## RONALD MCNAIR ELEMENTARY SCHOOL

MANDATORY REFERRAL NO. MR2022014

### Description

No. MR2022014

Figure 6: Pedestrian Access

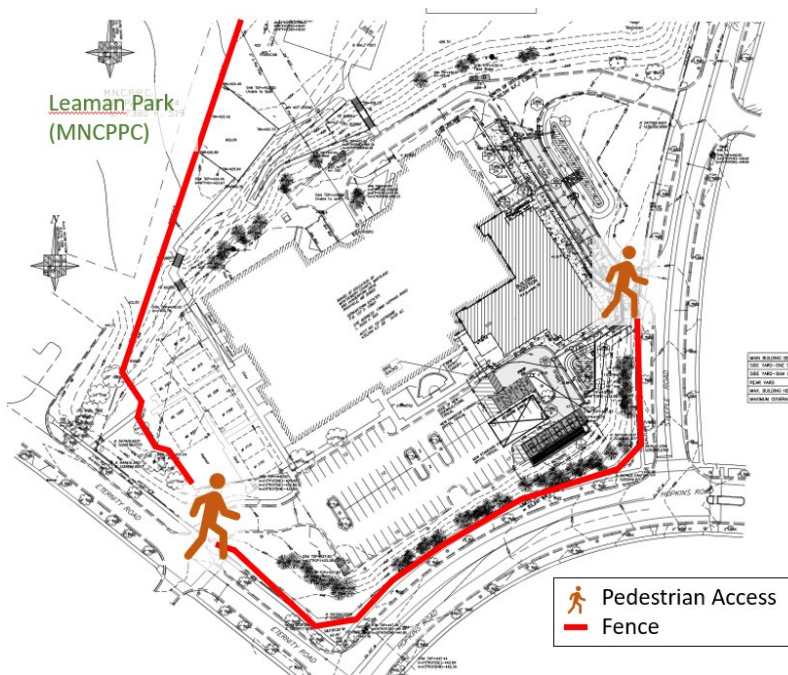
Pedestrian access will remain limited. Two existing access points will remain (Figure 6): one along the vehicular access point on Eternity Road and one along Steeple Road.

Fencing along the perimeter of the property currently restricts access, particularly to Leaman Park adjacent to the west of the Site. The park provides a pedestrian path connecting the park to neighborhoods to the north, but the lack of connection between the school and the park limits potential mutually supportive interaction between these public facilities while placing a barrier to pedestrian access to the park for communities to the north and east. This is recommended to be improved by MCPS in conjunction with Planning and Parks staff.

Similarly, fencing and grading immediately along Hopkins Road restricts pedestrian access. Prior to the installation of fencing, a dirt path was one of the preferred routes from the northwest corner of the Steeple Road / Hopkins Road intersection to the main school entrances. Due to the significant grade and safety concerns, MCPS has restricted that movement.

Figure 7: Proposed Retaining Wall

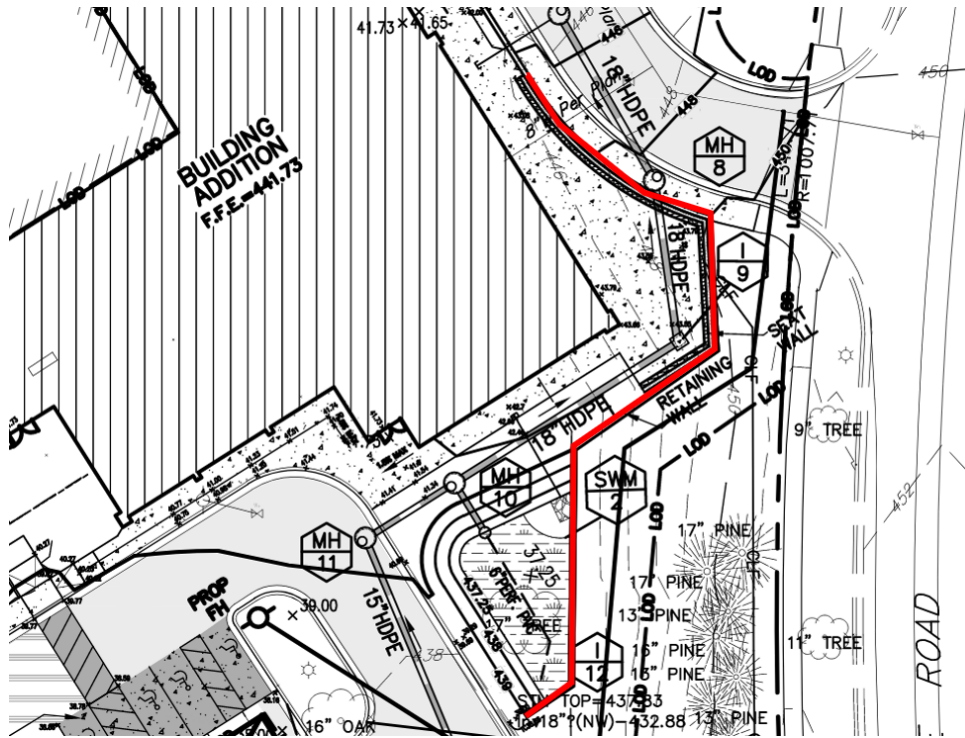
- Explore options to eliminate the proposed retaining wall in front of the proposed building extension, or other options to increase pedestrian access.

A new retaining wall is proposed in front of the new addition (Figure 7). This wall will separate the main entrance from public access off Steeple Road and serve as an additional hurdle for pedestrian access as well as limiting engagement with the public street. For pedestrians who wish to access school entrances along the Hopkins Road frontage from Steeple Road, the placement of the wall would require an approximately 150 ft. detour and serve as a behavioral cue to further reduce pedestrian access. MCPS is recommended to explore options to avoid the use of the retaining wall, or at a minimum, soften its appearance and reduce its impact on pedestrians with additional stairs and ramps.

Figure 9: Intersection of Bus Loop Exit and Steeple Rd, As Seen from Bus Loop Exit.

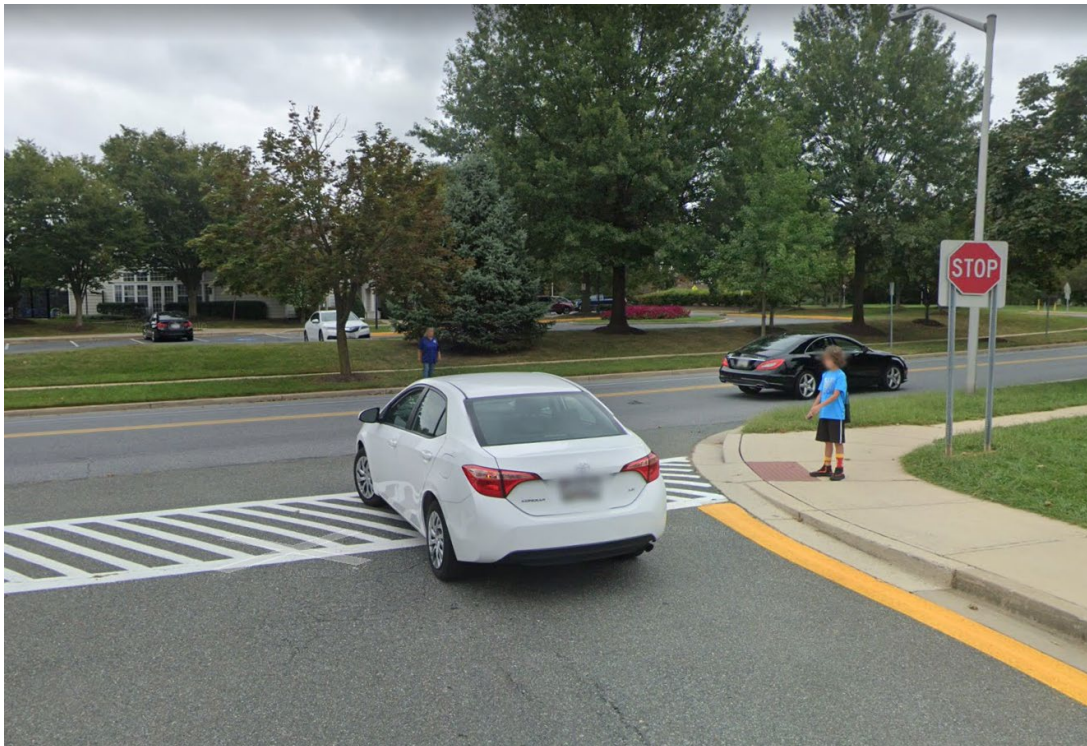
- Provide crosswalks across Steeple Rd. at the two bus access points.

Similarly, MCPS should explore options to reduce the width of the vehicular access points to the school, all of which require a pedestrian crossing distance of 30 feet. Additional crosswalks should be explored in these locations to cross Steeple Road.
